REMARKS

Enclosed herewith is a Request for a Continued Prosecution Application under 37 CFR 1.53(d).

FIG.4

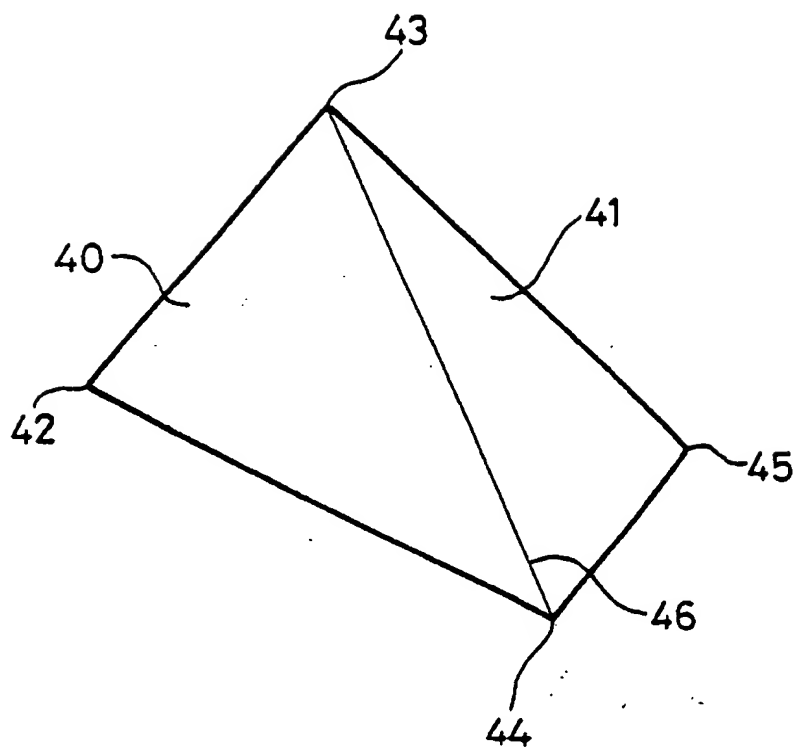
Attached to this amendment, is a marked copy of Figure 5 of the present application. In the first full paragraph of page 4 of the Examiner's Office Action, the Examiner questions the numbering of the lines. The Examiner is correct. The facet 40 of Figure 4 is defined by the points 42, 43, and 44 while the facet 41 is defined by the points 43, 44 and 45. In Figure 5 where a new rank point 47 is provided, it is evident that the facets labeled 40 and 41 in Figure 5 do not correspond to the similarly numbered facets in Figure 4. That is, the facet 40 in Figure 5 is defined by the points 42, 44 and 47 while the facet numbered 41 in Figure 5 is defined by the points of 43, 45 and 47. Accordingly, with the submitted drawing of Figure 5, these facet numbers have been changed to 40' and 41' respectively. This would indicate that facet 40' has some commonality with facet 40, namely, the segment defined by points 42 and 44. Similarly, the facet 41' has commonality with facet 41, namely, the segment defined by points 43 and 45.

It is hoped that these changes will be satisfactory for the Examiner's purposes. Changes have been made in page 6 of the specification to account for the change in numbering.
